TRACT J, STERLING RANCH EAST FILING NO. 1 (D20 MIDDLE SCHOOL SITE)

GRADING AND EROSION CONTROL PLANS

PCD No. CDR267

DESIGNED BY	KES	SCALE	DATE	6/26/2026
DRAWN BY	KES	(H) 1"= 100'	SHEET	2 OF 4
CHECKED BY		(V) 1"= N/A	JOB NO.	1183.30

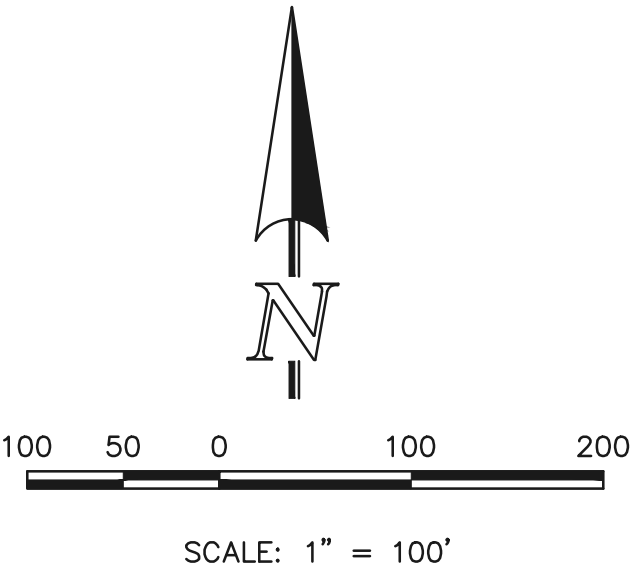
General comments/questions about this plan:

- Are the area 3 inlets on this sized to collect flows from all 38ac?
- I'm concerned that with all of the random grading/stockpiles on this site (past, present, and future), there isn't much organization/thought to the grading actually getting to the inlets and thus to Pond 14A. And if the flows don't get to the inlets, 36ac of runoff is obviously way too much for some silt fence to handle. So need to come up with a plan for this and show it on here. Ideas:

- There should probably be swales/berms at the SW side of the site to convey flows to the 3 inlets.
 - Besides that, there should probably be a TSB on this site. I'm guessing Classic wants to call Pond 14A the TSB for this site, but if Sterling Ranch Rd is going to be accepted soon, then the conveyance pipes from this site to Pond 14A will be maintained by EPC, and EPC does not want a ton of sediment from this site in our pipes. Meaning the runoff should be treated before entering our pipes. If you want to see if you can use EPC pipes without a TSB, we can talk to Brad and Ben about what would be needed (like some kind of agreement that you all will clean out the pipes when sediment accumulates in them). Because we don't want to have to frequently issue Illicit Discharges notices for Classic for getting sediment all in the pipes.

Give me a call if you'd like to discuss.

DRAWING NO. 800-08-2

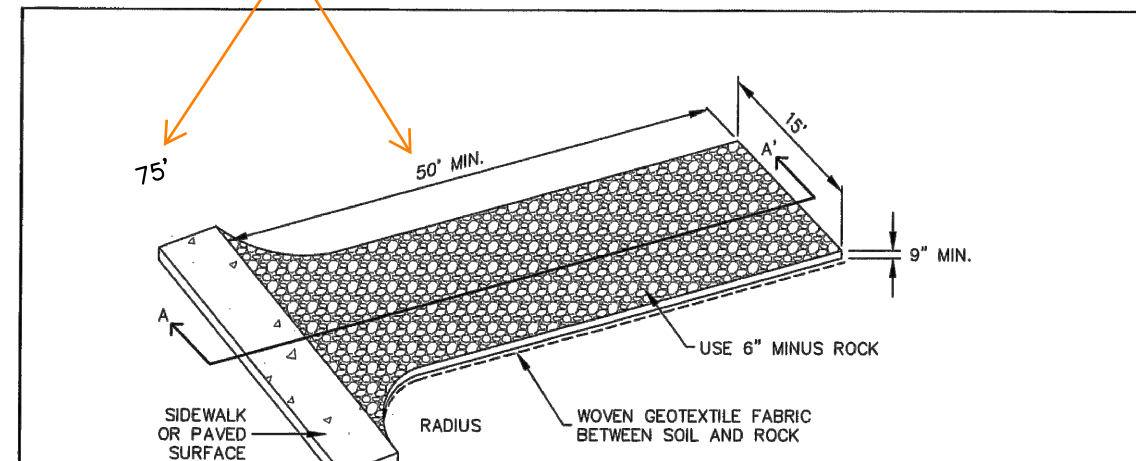
move the 75' text over closer to the 50' text and cross off the 50' text.
